ADDENDUM NO. 1

This addendum modifies the Contract Documents dated December, 2022, for the San Lorenzo Valley Water District Redwood Park Pipeline Project, and the work shall be accomplished in accordance with such modifications. This Addendum includes two (2) pages plus three (3) attachments (total of 13 pages).

REDWOOD PARK PIPELINE

C-3.1

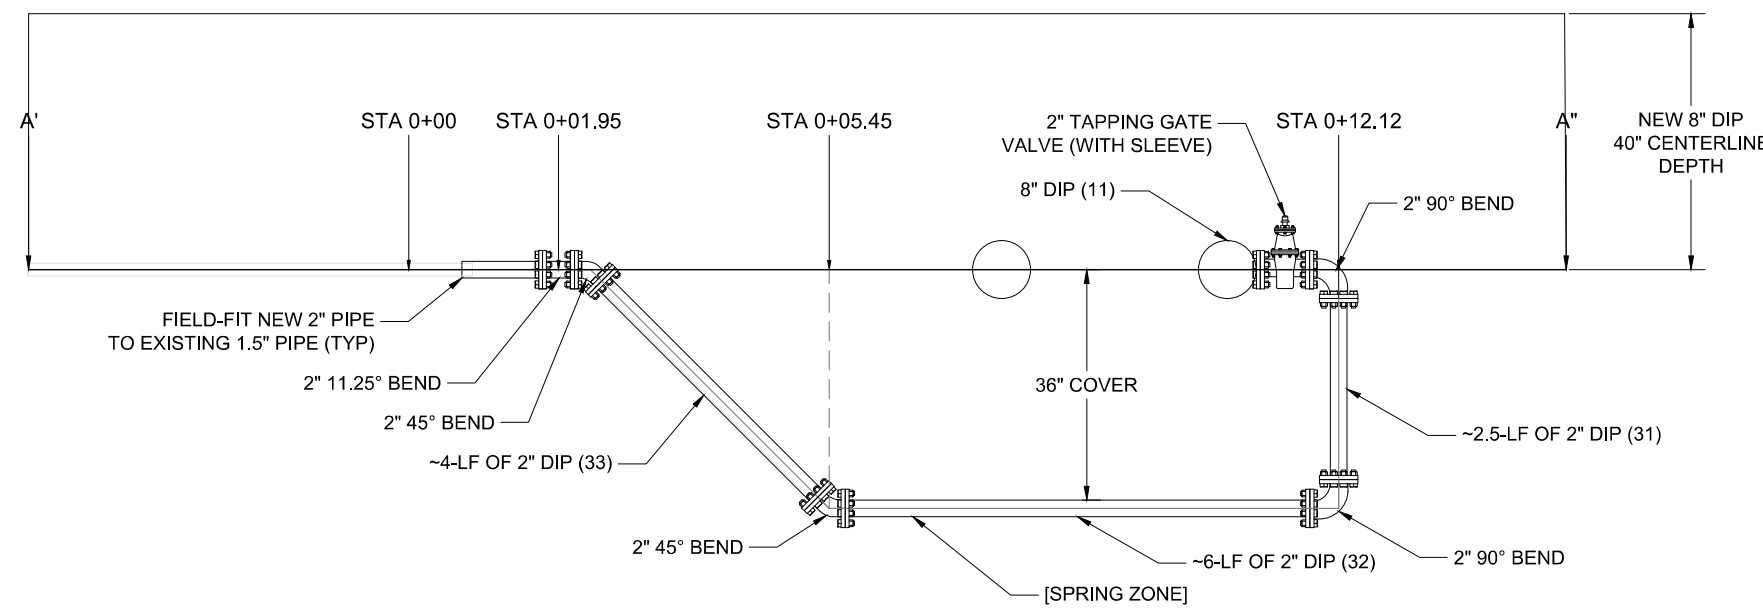
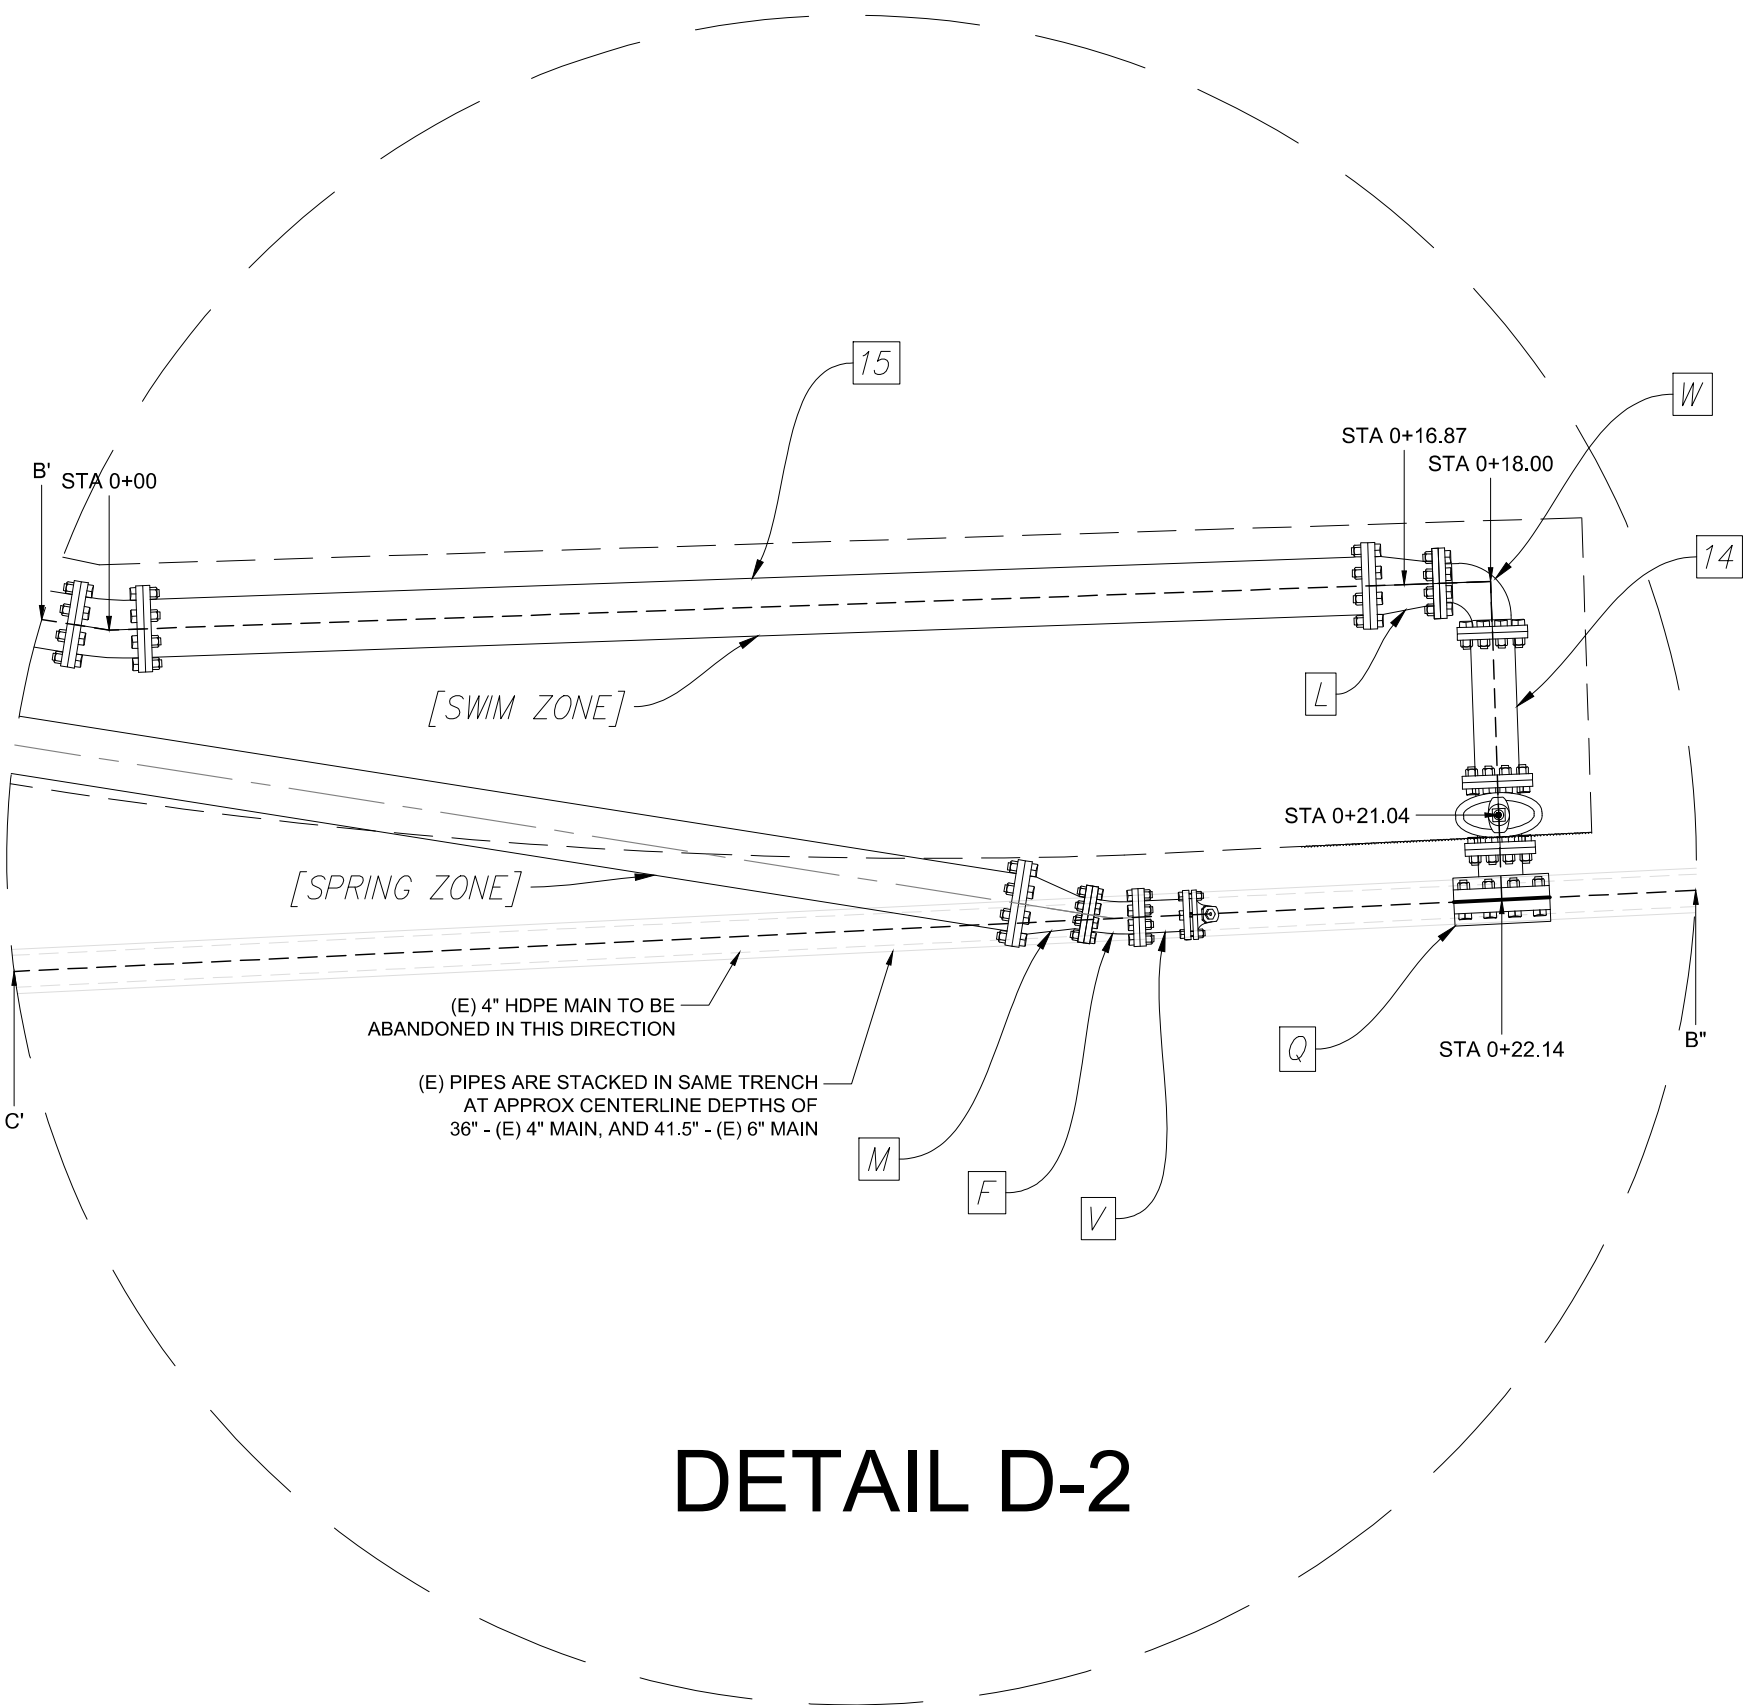
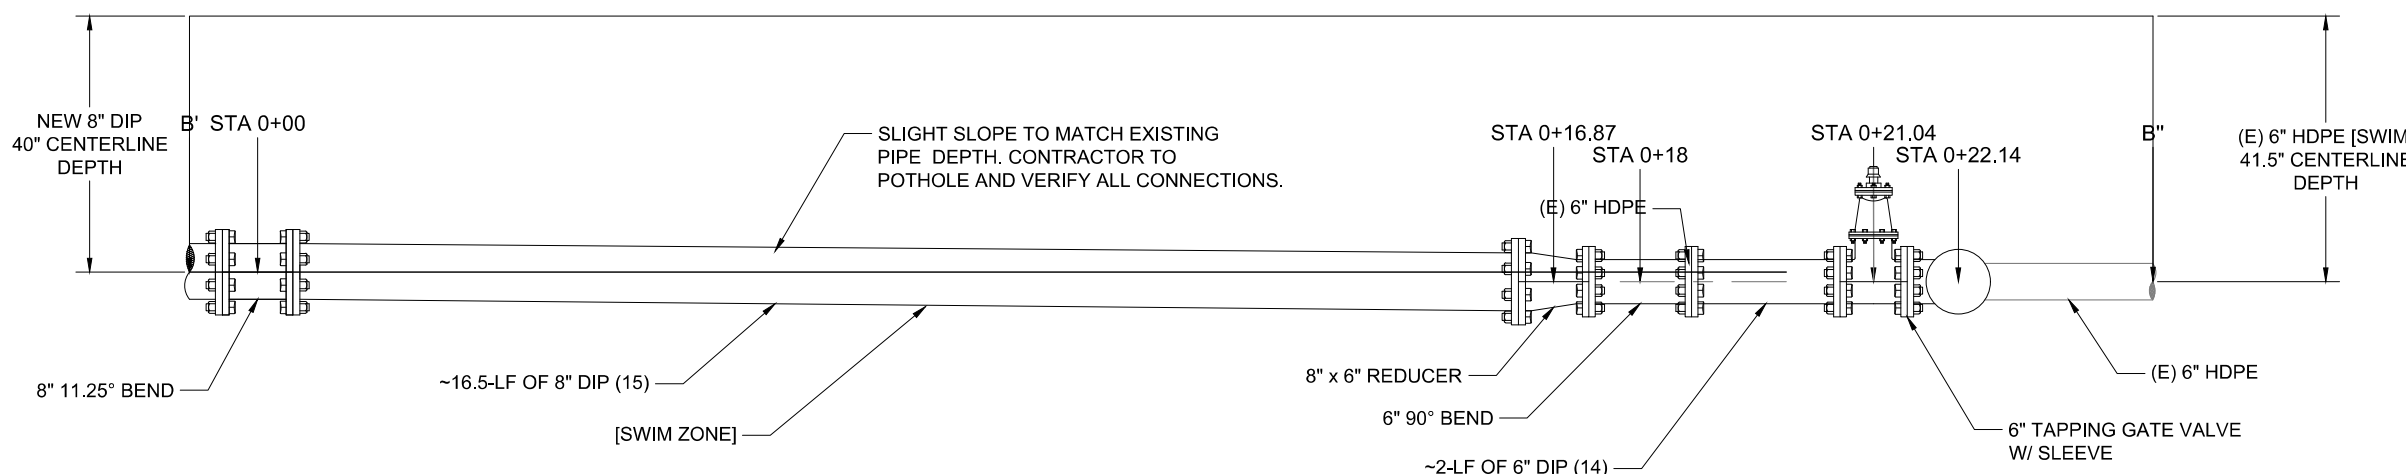
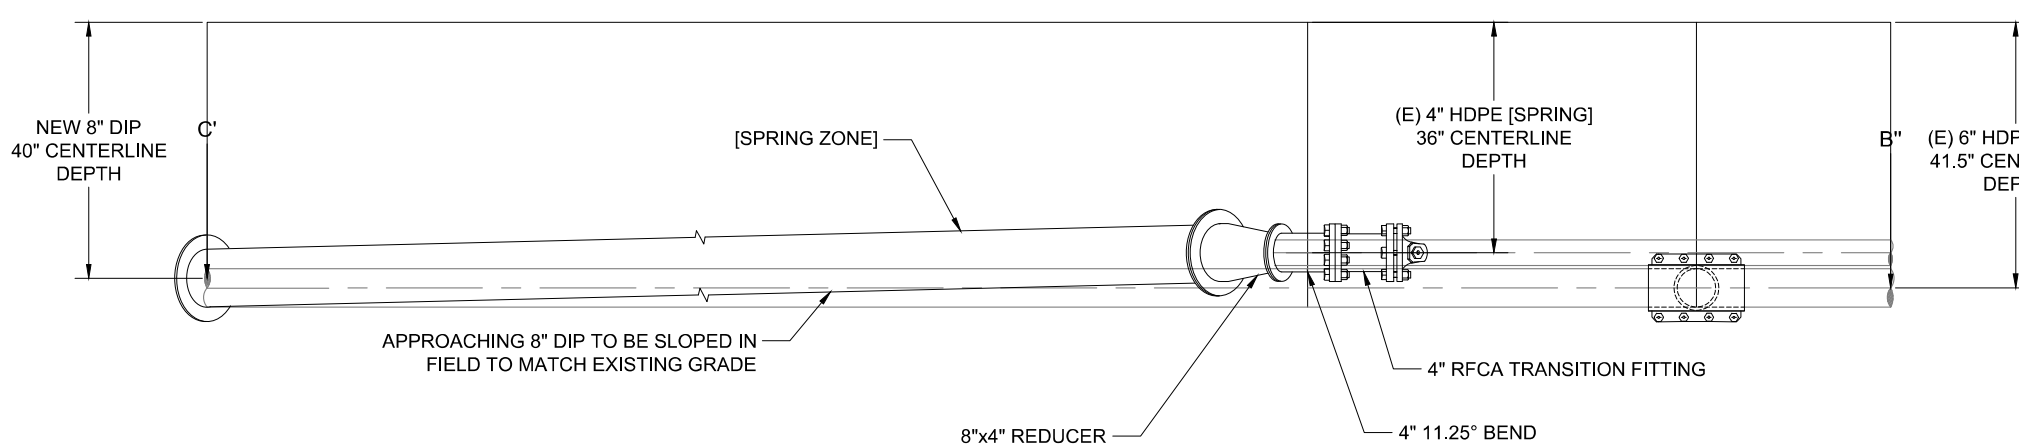
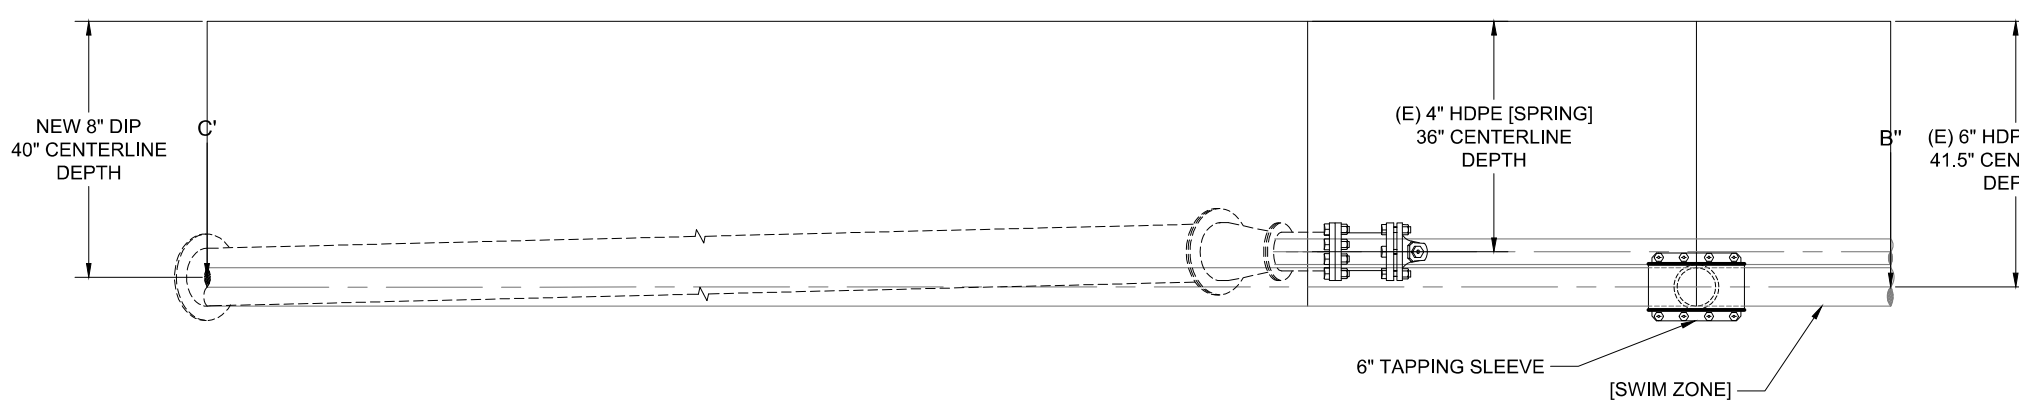
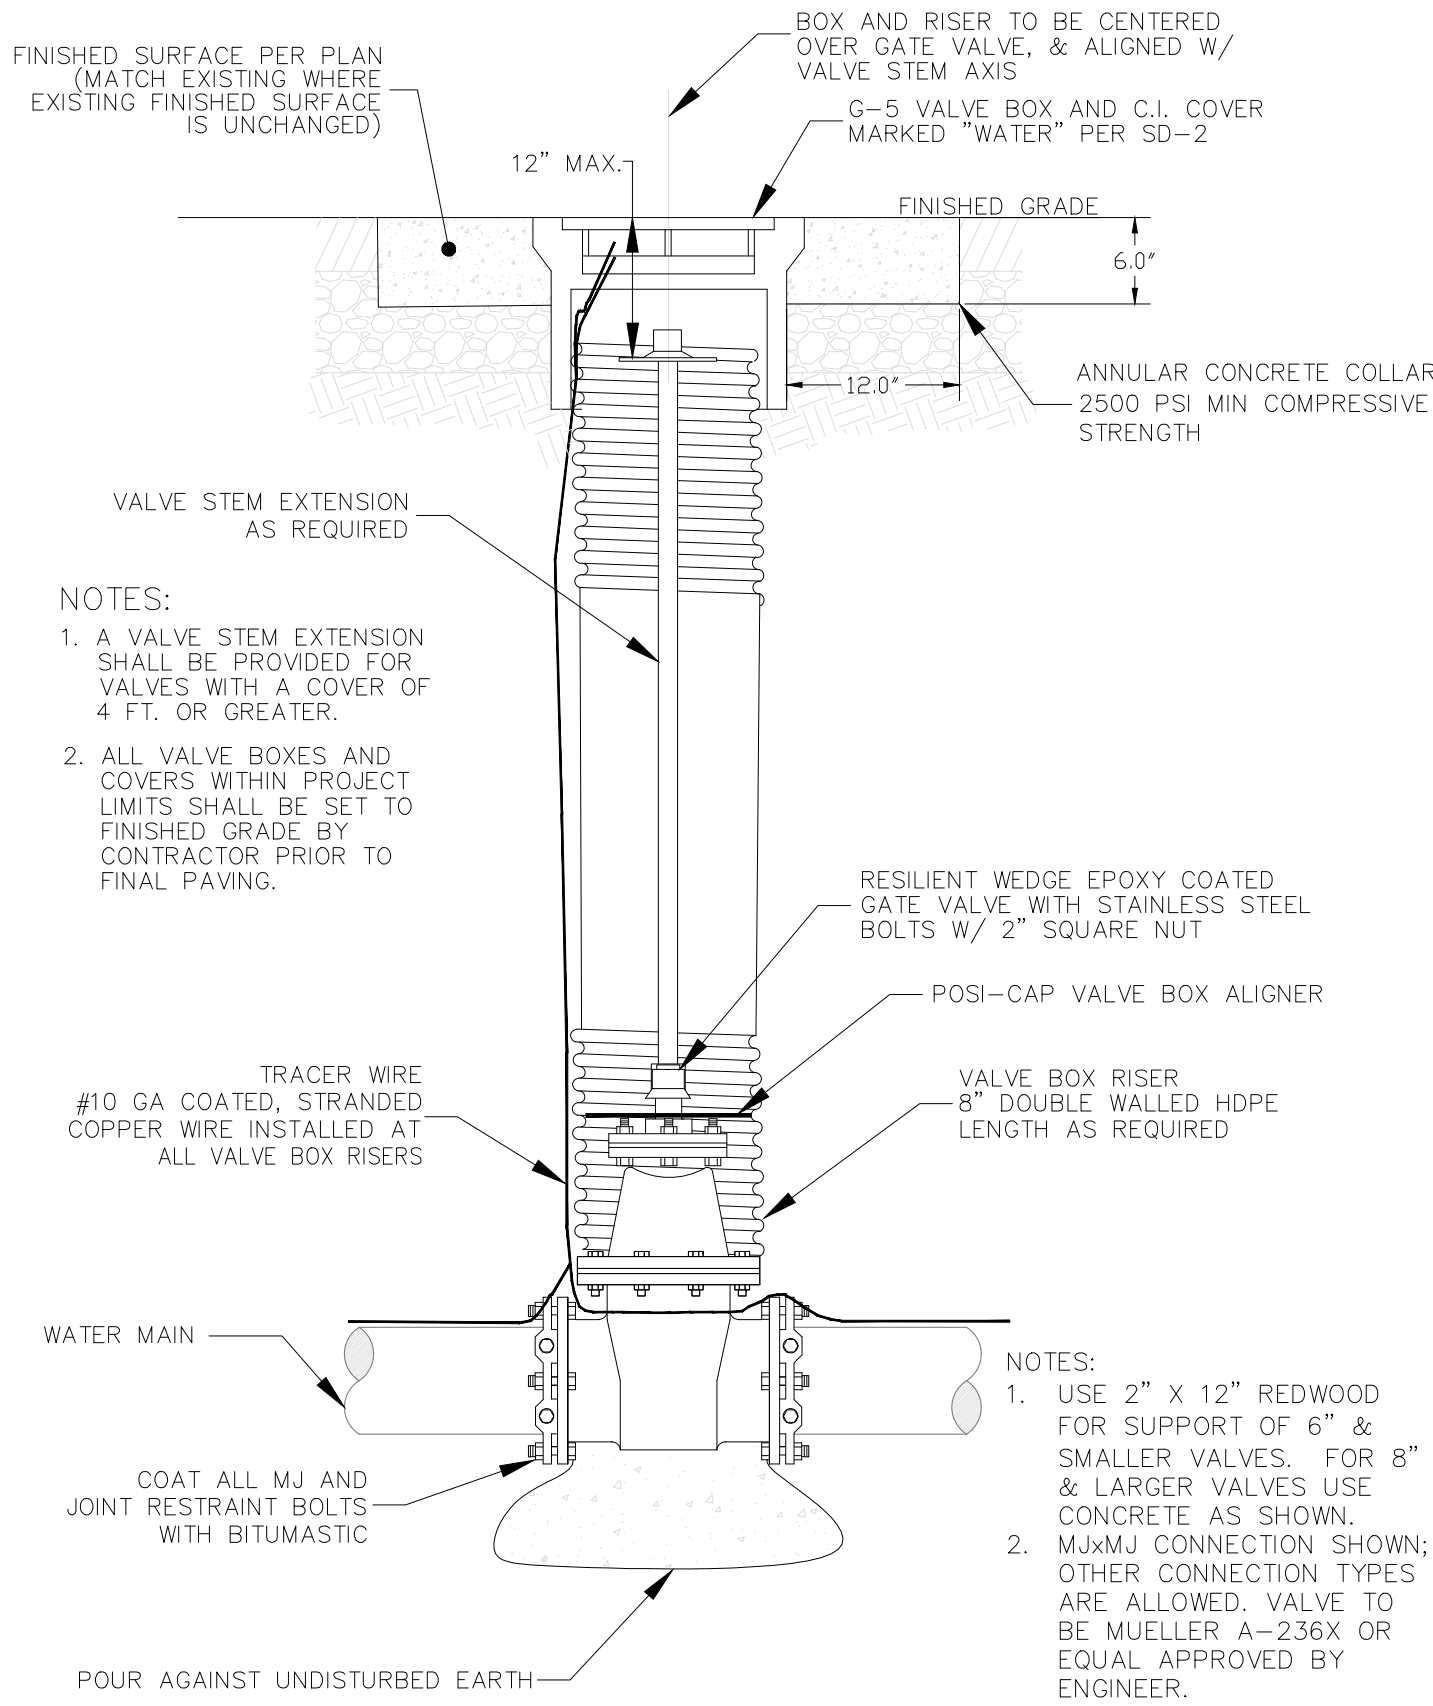
“23. Minimum wall-to-wall separation between pipes is to be 12-inches, unless otherwise specified.”
- B. Sheet C3.0, Proposed Site Plan is revised. The changed sheet is attached.
- C. Sheet C3.1, Proposed Details is revised. The changed sheet is attached.
- D. Sheet C4.0 Utility Details is revised. The changed sheet is attached.
